**ADDENDUM NO.: 1**

**RE: BID PROPOSAL NO.: 2285-01934**

**SUBJECT: HUNTER'S FIELD PHASE II REBID**

**Hunter's Field Phase II Improvements**  
 at 1659 North Claiborne Avenue, New Orleans, Louisiana 70116  
 a New Orleans Recreation Development Commission (NORDC) facility  
 for the City of New Orleans

**C-1**

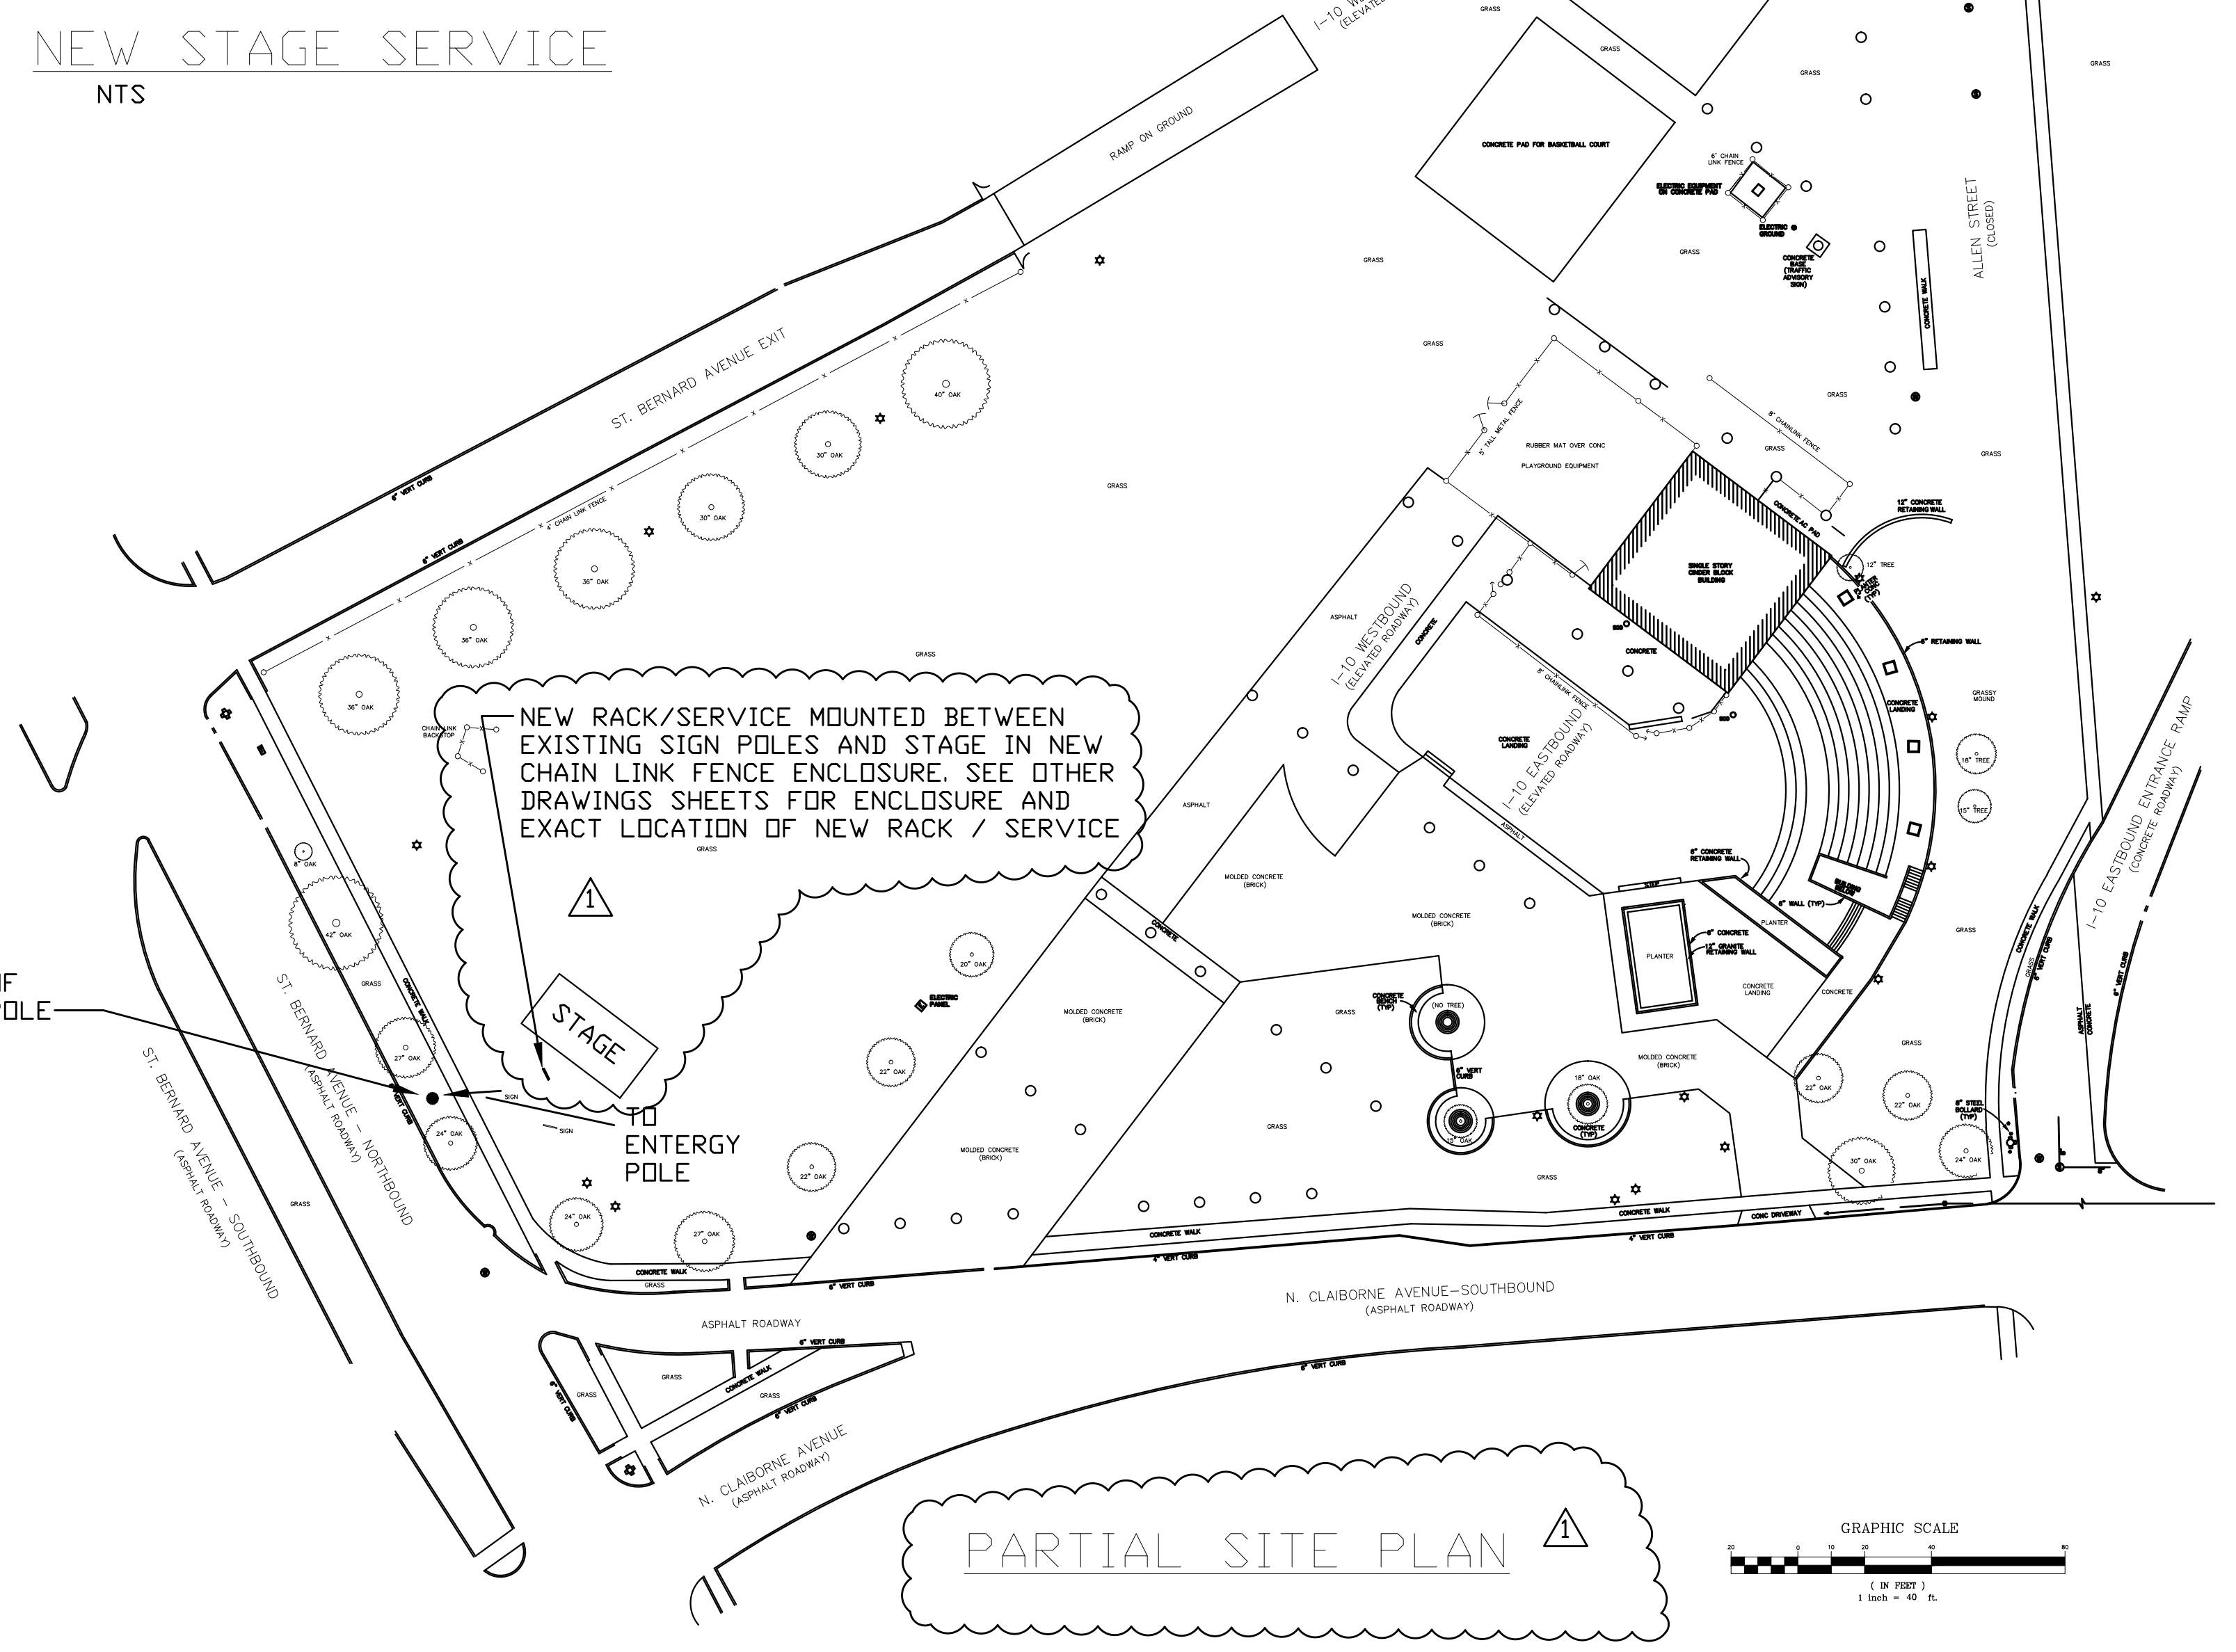
- B. On Sheet C-1, dated October 28, 2015, delete Scope of Civil Work Key Note #2 text, "INSTALL CRUSHED LIMESTONE. SEE LANDSCAPE ARCH. DRAWINGS FOR DETAILS.", and insert instead , "NOT USED. DISREGARD THIS KEY WHEREVER IT APPEARS IN THE CIVIL SITE PLAN AND DISREGARD ANY DRAWN WORK INDICATED BY THIS KEY ."

- C. On Sheet C-1, dated October 28, 2015, insert at the end of Scope of Civil Work Key Note #3, "SEE ALLOWANCES REGARDING REPAIRS TO DRAIN LINES."
- D. On Sheet C-1, dated October 28, 2015, delete Scope of Civil Work Key Note #6 text, "SMALL SINKHOLE AREAS IN GRASSY AREA SHALL BE BACKFILLED WITH PUMP SAND TO MATCH EXISTING NATURAL GRADE AND SEEDED.", and insert instead , "NOT USED. DISREGARD THIS KEY WHEREVER IT APPEARS IN THE CIVIL SITE PLAN AND DISREGARD ANY DRAWN WORK INDICATED BY THIS KEY ."

- E. On Sheet C-1, dated October 28, 2015, delete Scope of Civil Work Key Note #7 text "REGRADE AREA TO SLOPE TO EXISTING DRAINS. APPROX. 772 SY. SEE LANDSCAPE DRAWINGS FOR NEW SURFACE WORK AT THIS AREA." and insert instead "NOT USED. DISREGARD THIS KEY WHEREVER IT APPEARS IN THE CIVIL SITE PLAN AND DISREGARD ANY DRAWN WORK INDICATED BY THIS KEY ."

- F. On Sheet C-1, dated October 28, 2015, delete Scope of Civil Work Key Note #8 text, "INSTALL NEW 6" CURB. SEE LANDSCAPE ARCH. DRAWINGS FOR DETAILS.", and insert instead , "NOT USED. DISREGARD THIS KEY WHEREVER IT APPEARS IN THE CIVIL SITE PLAN AND DISREGARD ANY DRAWN WORK INDICATED BY THIS KEY ."
- G. On Drawing 4 of Sheet C-3, dated October 28, 2015, add the note, "NOTE: PROVIDE NEW 6X6 4/4 STEEL WELDED WIRE MESH REINFORCING AT THE MID-HEIGHT OF ALL NEW CONCRETE."
- H. In the title blocks of the Civil, Electrical, and Landscape Drawing sheets, delete the project site address zip code "70113" and insert instead "70116".

GUTTER DETAIL  
N.T.S.

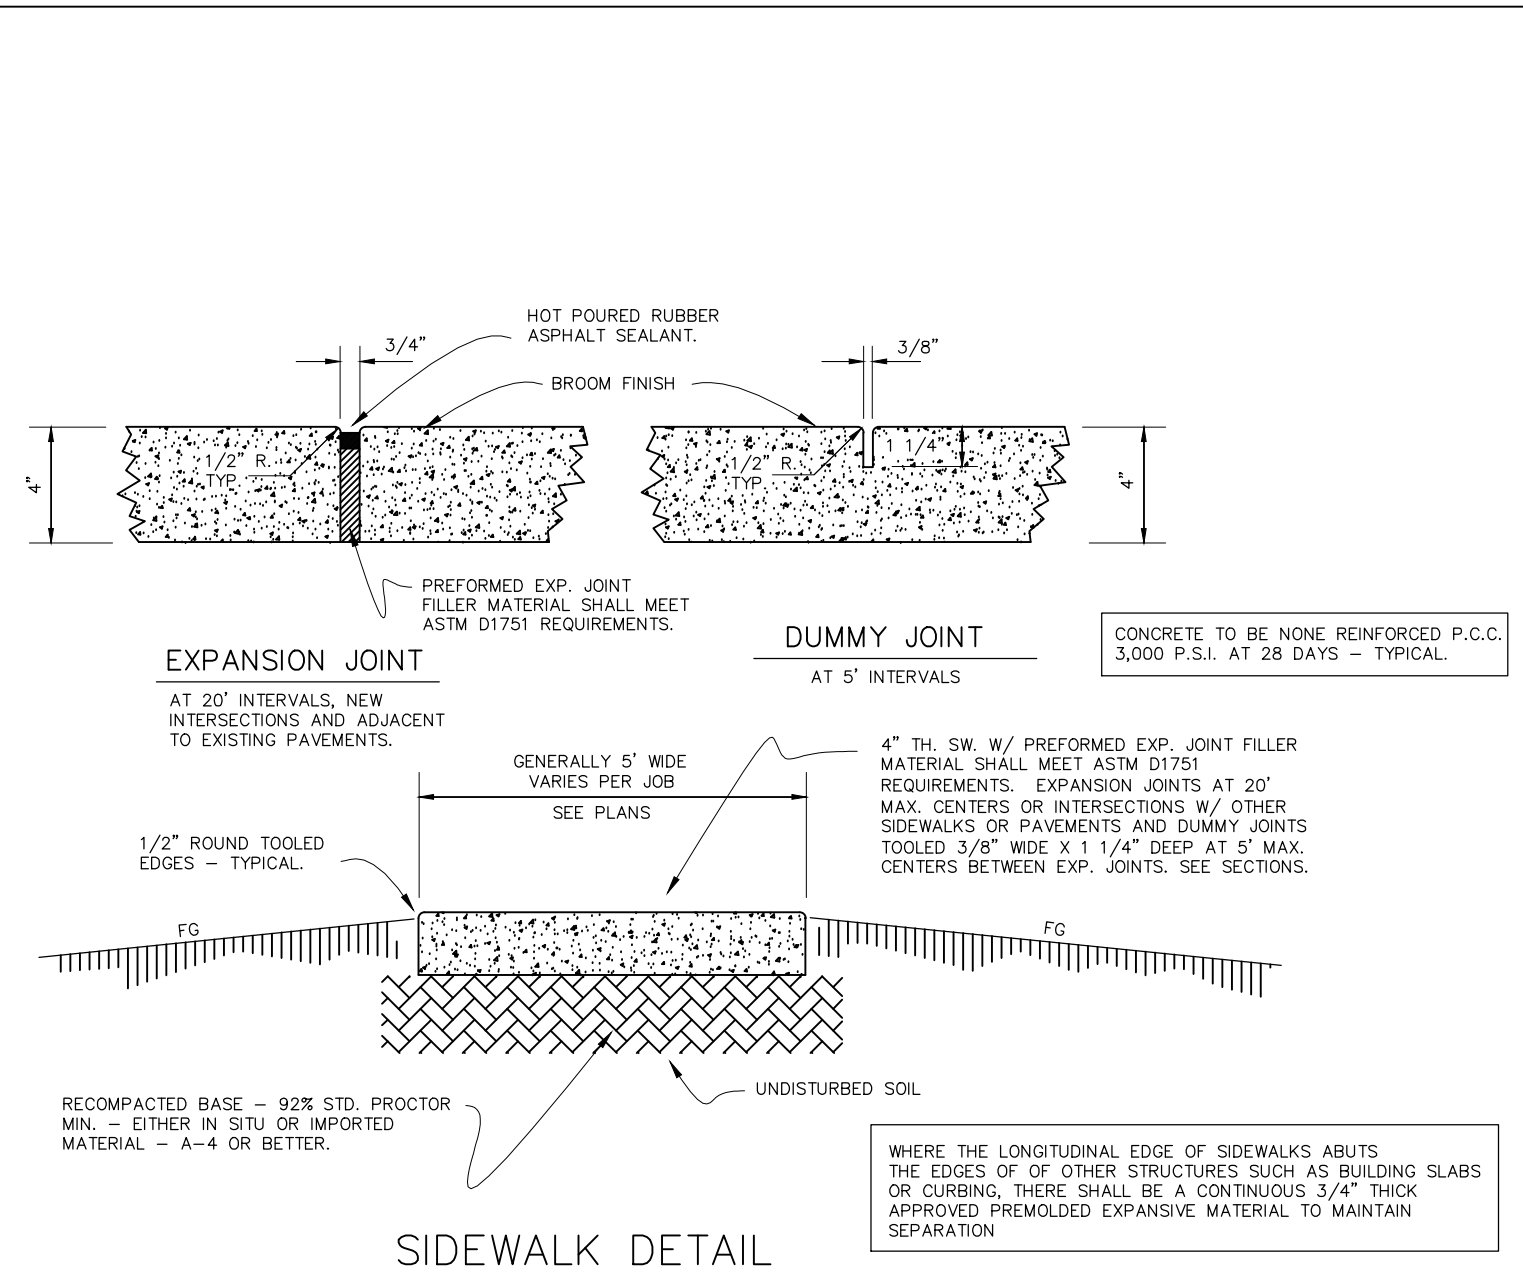
**Q3:** Can you please clarify the permitting and/or approval requirements for the gutters that will be attached to I-10?

**A3:** See revised Civil drawings that are a part of this Addendum. There will be only one gutter assembly attached to I-10, and it replaces an existing damaged gutter assembly at the same location. The new gutter assembly

shall be an in-kind replacement with regard to size and location. As indicated in Project General Note #8 on drawing sheet G-1, the Contractor shall acquire all required permits; neither the Designer nor the City of New Orleans shall be responsible for providing a definitive list of required permissions or for providing details about how to apply for required permits/approvals. The Designer and the City of New Orleans will make a reasonable effort to provide specific documents and information when such specific information is requested by the Contractor for purposes of permit/approval applications. See Project General Note #20 on the Sheet G-1 that is a part of this Addendum for further information.
